Access Report

Astra Aerolab
Cabbage Tree Road
WILLIAMTOWN NSW

For: EJE Architecture

Ref: LP_22180

Figure 2 | Overall Site Plan

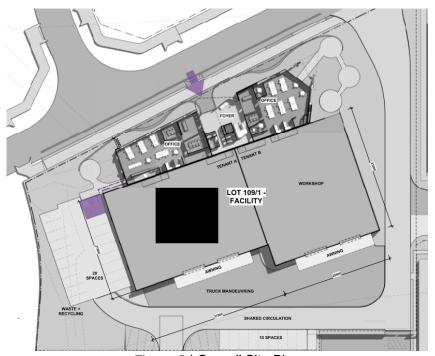
An accessible path of travel is provided to the building entrances from the allotment boundary along Aerospace Avenue via pathways that are level.

An accessible path of travel is provided from carparking areas generally to the building entrances.

There is one (1) accessible car parking space provided within the Lot 109/1 carparking area from a total of twenty (20) spaces.

The overall configuration of the accessible car parking is in keeping with current accessibility requirements including overall dimensions and provision of a bollard.
